701 5th Avenue North | Seattle WA 98109

DESIGN REVIEW: Recommendation Proposal
(DPD #3015918)

Prepared for F&M Development
September 21, 2016

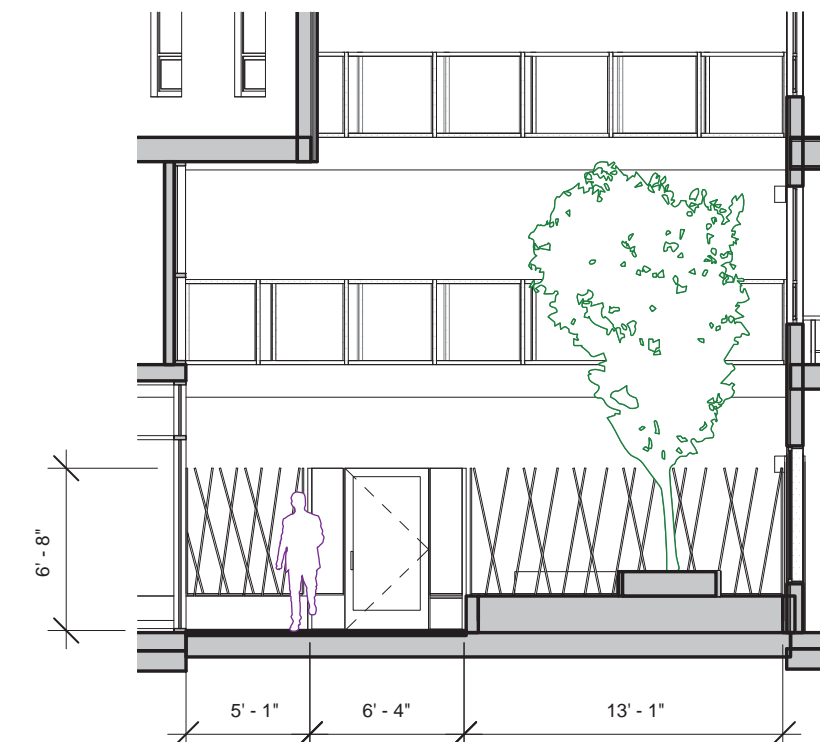
"The Board supported the proposed location of the entry on the preferred alternative; however, they expressed that they would be open to other locations of the entry as a result of the revised massing. The prominence, legibility, and visibility should be critical design considerations..."

...The entry should make a strong gesture to the public realm."

The courtyard entry gate provides a necessary separation between public and private spaces, while acting as an artistic expression, rather than a rigid barrier.

The angular, blackened steel gate members reinforce the design language of the acute, exterior building walls that bound the open green spaces within the courtyard.

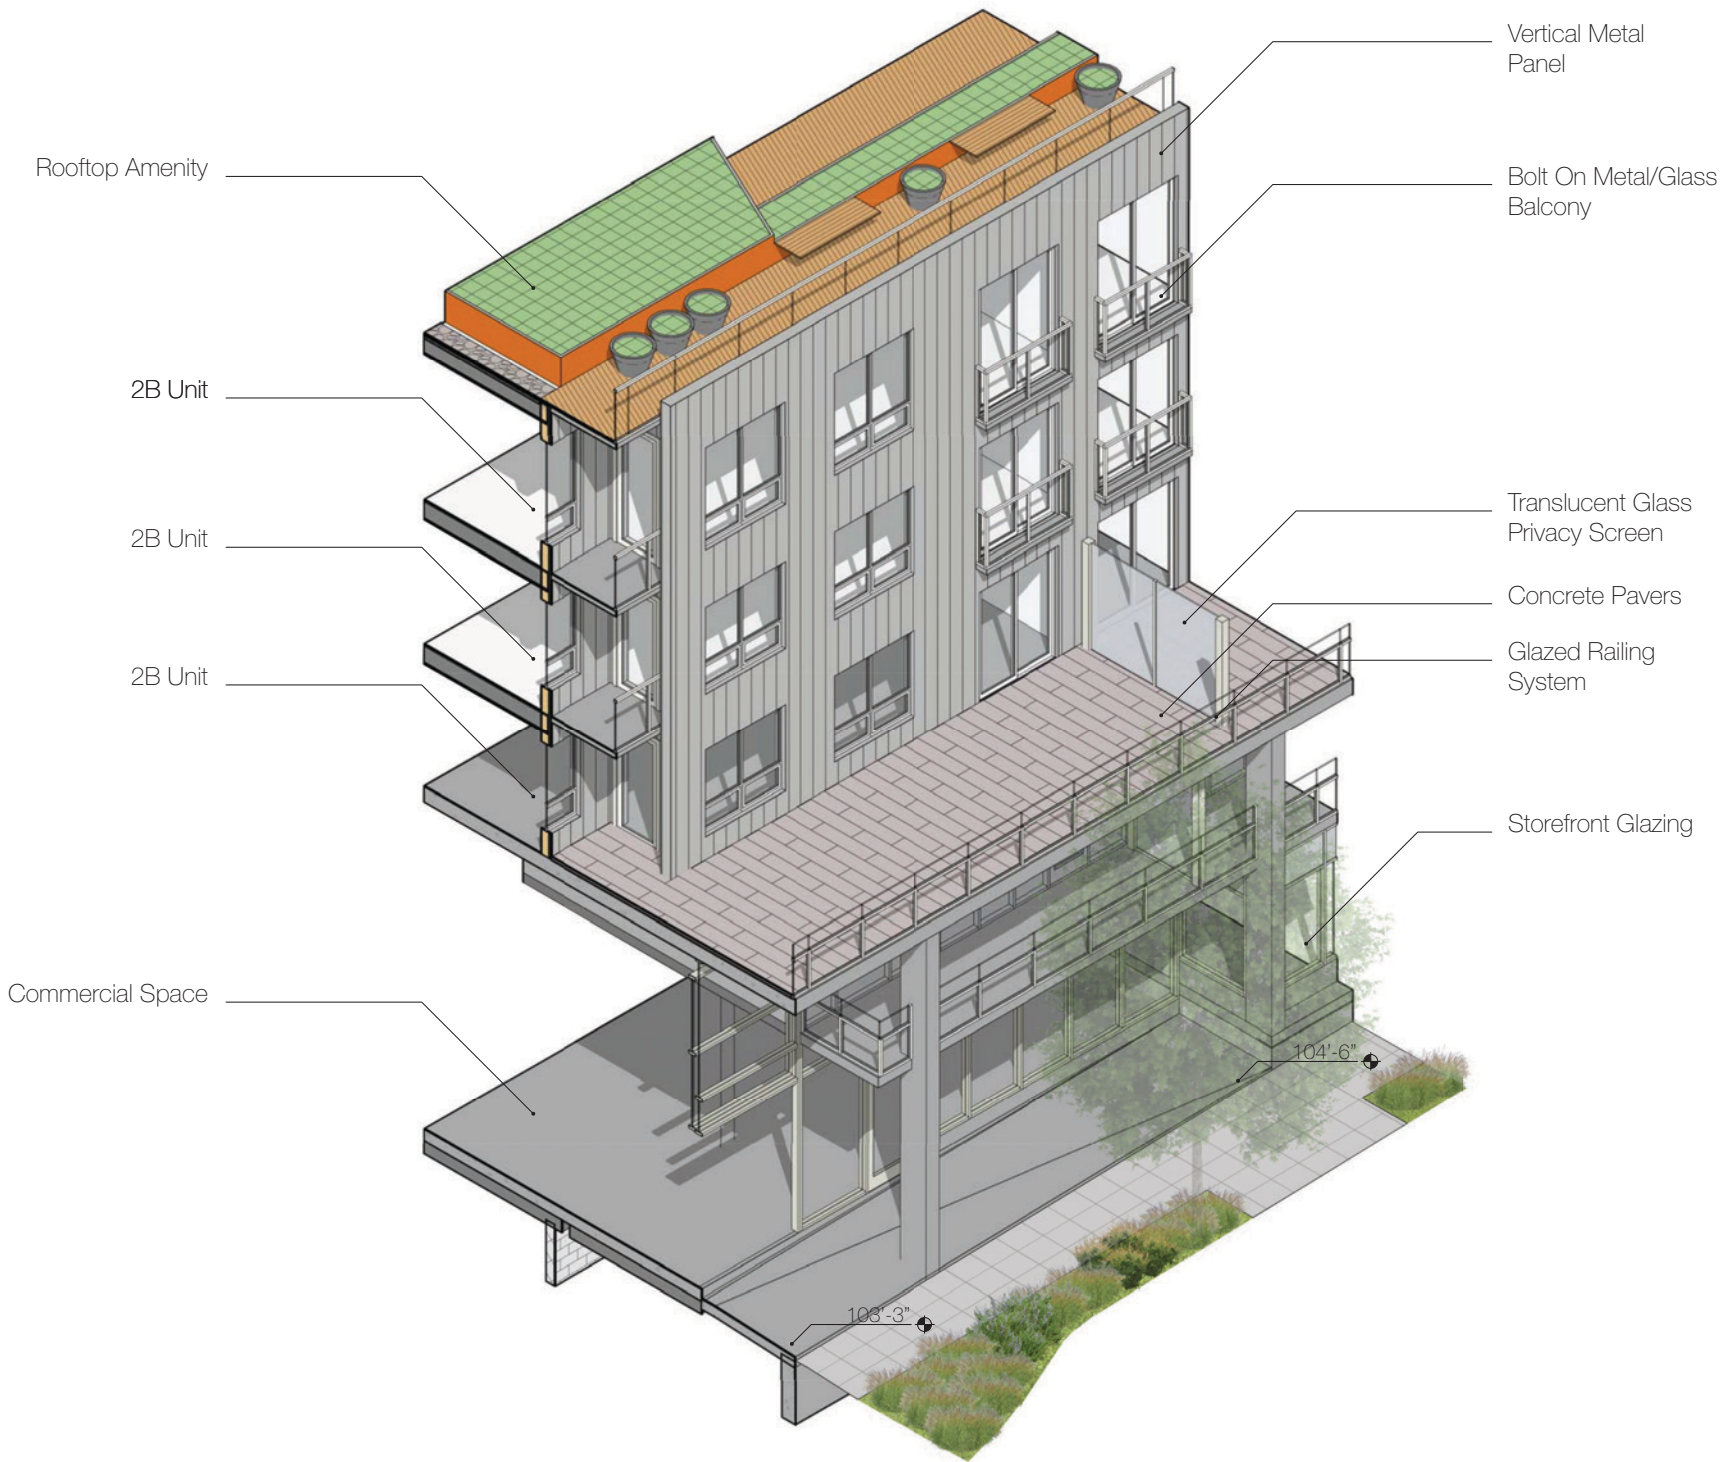
Massing and Design Concept:
"a. The Board noted that Option 1 and Option 3 were more difficult to read programmatically, and that Option 2 was more successful due to the change in character of massing and modulation on Roy Street, 5th Ave. N, and Valley Street. (CS2-A, CS3-A, DC2-A, DC2-E)

b. The Board supported the courtyard layout and massing of the preferred option overall, but noted that the strong linearity of the third story modulated "bar" did not respond well to the lack of activity across 5th Ave. N. The Board saw the modulation presented in Option 2 as a more sensitive response to this condition, and recommended incorporating the movement and interest created to establish a stronger street presence. (CS2-A, CS3-A, DC2-A)

d. The Board discussed the success of the demarcation of the massing of the townhouses at the north end with the inset along 5th Ave. N; however, there was concern over the east façade of the north massing creating a blank façade. The merits of continuing the design language over the entire length of 5th Street, as presented in Option 2, was also discussed. While no consensus was reached, the Board expects the massing and design response to programming to be intentional, and to make a strong statement with each distinct portion of the building. (CS2-I, CS2-II, DC2-B, DC2-D, DC2-E)"

The massing of the building has been modified to express the internal program, acknowledge differences in the street character, and offer a more active pedestrian experience. It does so by expressing the mass in five ways:

A two-story high concrete frame with glass infill at the intersection of 5th Ave North and Roy Street, expressing a larger scale commercial presence at the corner.

A series of bays along Valley Street and the north half of 5th Ave, reflecting a distinct residential character.

A four-story high residential open entry way and lobby with access bridges spanning above at mid-block on 5th Ave, providing a presence to the entry of the residential structure, views of the courtyard and interest to the street.

Capping the concrete frame and glass infill elements, residential bays and mid-block opening along 5th Ave are 2-3 stories high, while residential floors tie the lower level elements together for a unified composition.

At the roof, the common amenity rooms are moved closer to the east façade for a street presence, under a horizontal roof line punctuated with an opening, exposing a framed view to the sky, much like the lower level opening framing a view to the courtyard.

Valley Street

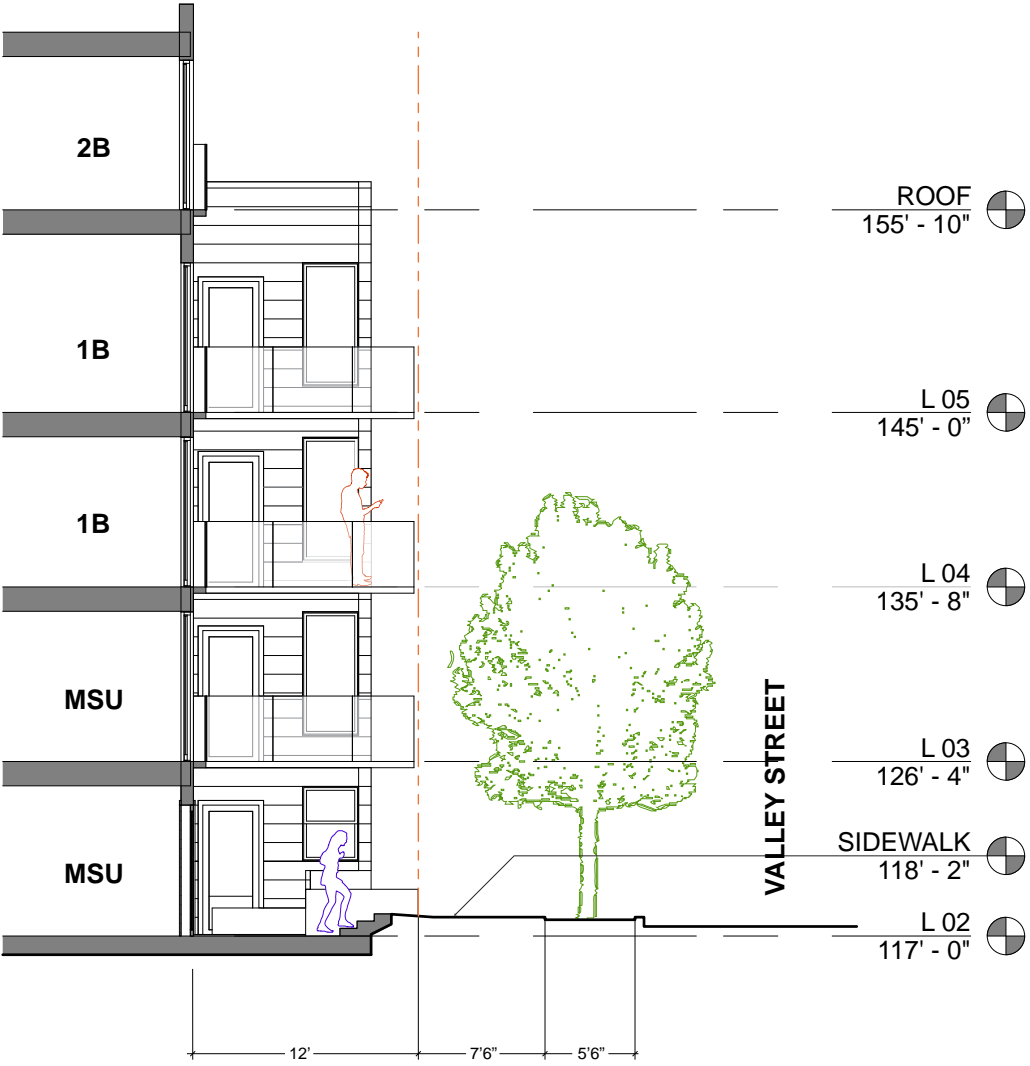
Board's Deliberations:
"The Board supported the setback individual townhouse unit entries and generous landscape buffers."

Response:
The east façade of the north massing is now composed of multi-story residential units with projected bays and bolt-on balconies.

The bays wrap the corner of 5th Ave and Valley St, which help strengthen the residential character of Valley and provide stronger continuity across the building massing.

Landscape elements including planters and walk-up patios are implemented to soften the building edge where it meets the sidewalk, while also providing a defensible space barrier for the future residential tenants.

Roy Street

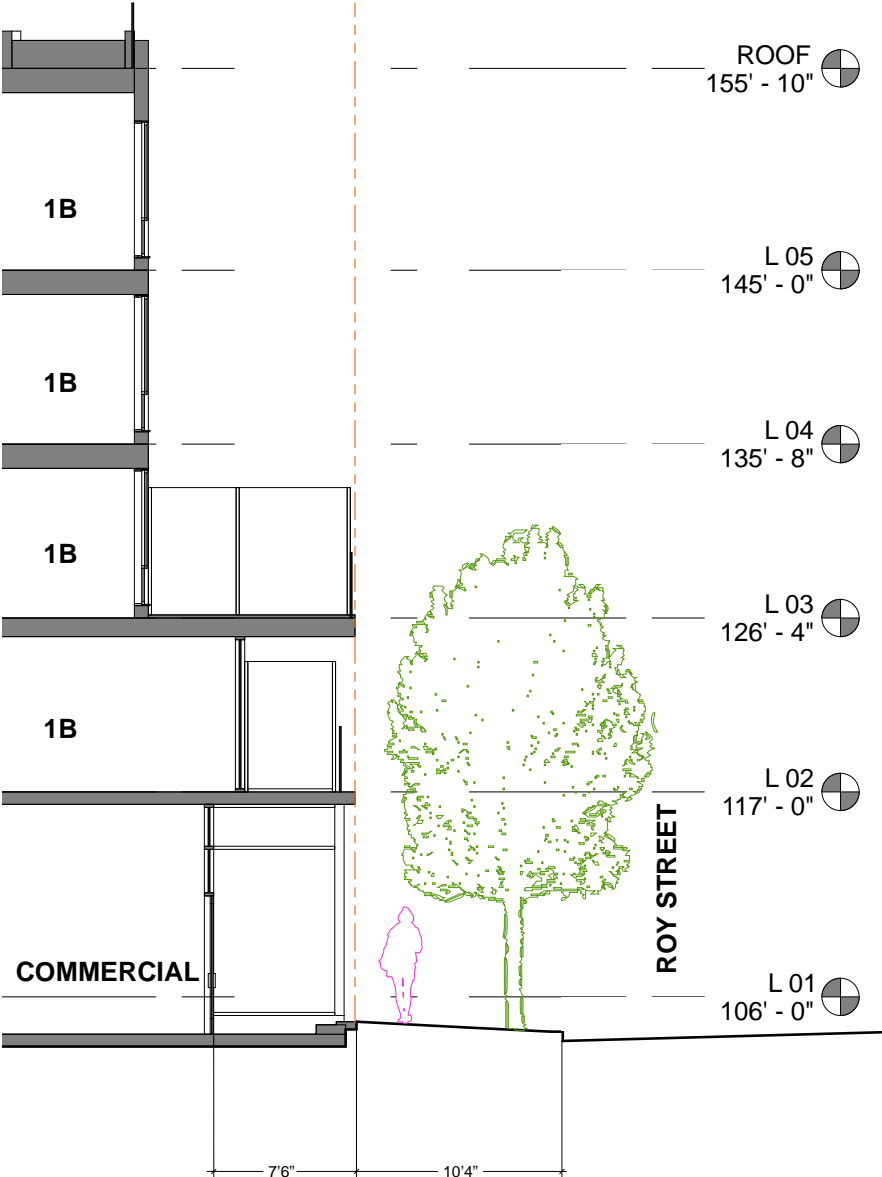
Street-Level Uses and Streetscape Design:
"The Board recognized and agreed that the design and programming of street-level uses needs to respond to the varied urban context of each street. In general, the Board noted that it is important that the project provide continuity in both texture and street-level use to the west along Roy Street and north along 5th Ave. N. (CS2-B, CS2-I)

a. Corner at 5th and Roy. The Board was generally supportive of the proposed commercial flex space at the corner of 5th and Roy Street, provided it is designed and programmed to encourage continuous activity, and that the spaces to the west along Roy Street are designed to successfully support commercial/retail functions. The flex space should express an outward-looking character and create a strong connection with the adjacent lobby to engage the corner. The Board recommended wrapping glazing around the corner to demarcate the special use at the prominent corner and establish a strong street presence. (CS2-A, CS2-C, PL3-C)

b. Roy Street. The Board expressed a desire for continuity of commercial uses and character along Roy Street. The proposed live-work units are set back and do not appear to make a strong connection to the street. Discussion over the grade change along Roy Street and potential stepping up of commercial spaces prompted the Board to encourage a strong connection of the commercial uses through design elements. (CS2-I, PL2-B, PL2-I, PL2-II, PL3-C)"

The internal program along Roy St, which wraps the corner for a portion of 5th Ave to the north, is now planned for commercial use.

The expression of the commercial space at the corner of 5th Ave and Roy St, is a two-story, glazed volume that adds a strong corner presence at this active intersection.

The commercial boundary along Roy St and 5th Ave is composed entirely of glazing, with proposed operable doors at the street corner that would provide the ability for an open, active outdoor setting that interacts with the public way.

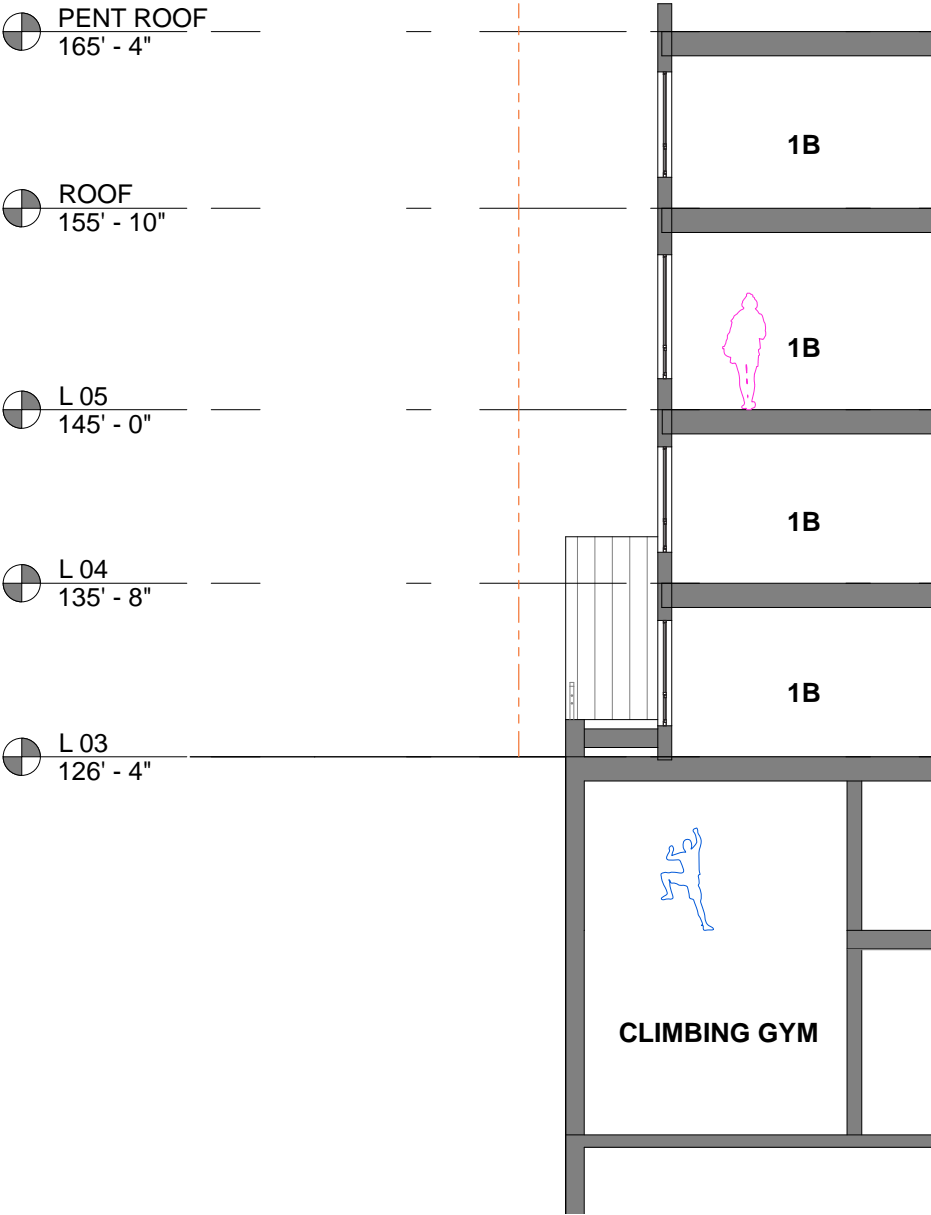
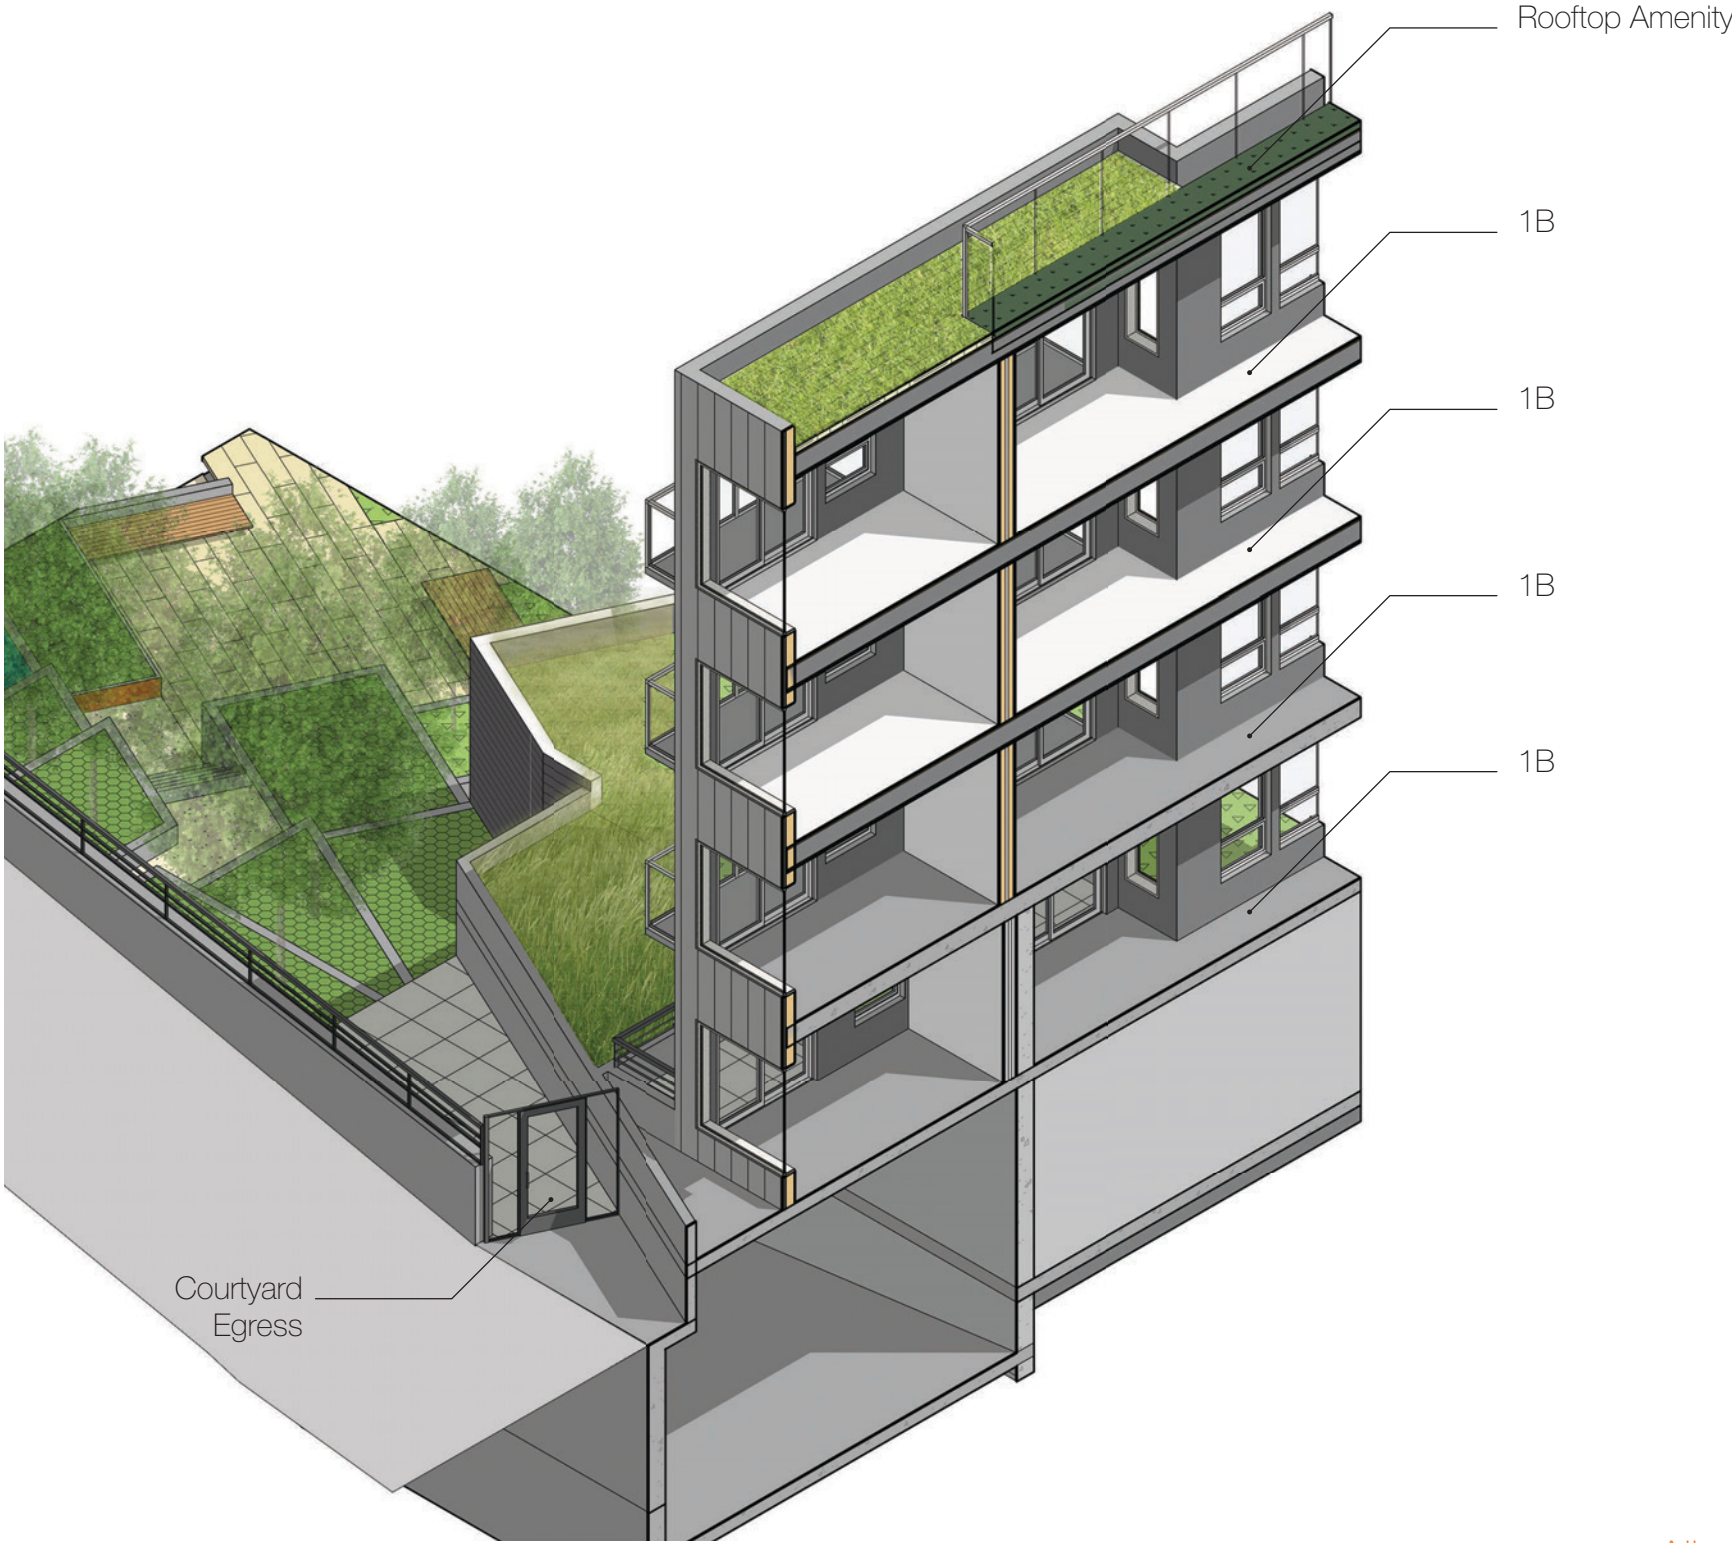
b. Roy Street. The Board expressed a desire for continuity of commercial uses and character along Roy Street. The proposed live-work units are set back and do not appear to make a strong connection to the street. Discussion over the grade change along Roy Street and potential stepping up of commercial spaces prompted the Board to encourage a strong connection of the commercial uses through design elements.
(CS2-I, PL2-B, PL2-I, PL2-II, PL3-C)

Capping the concrete frame and glass infill elements, residential bays and mid-block opening along 5th Ave are 2-3 stories high, while residential floors tie the lower level elements together for a unified composition.
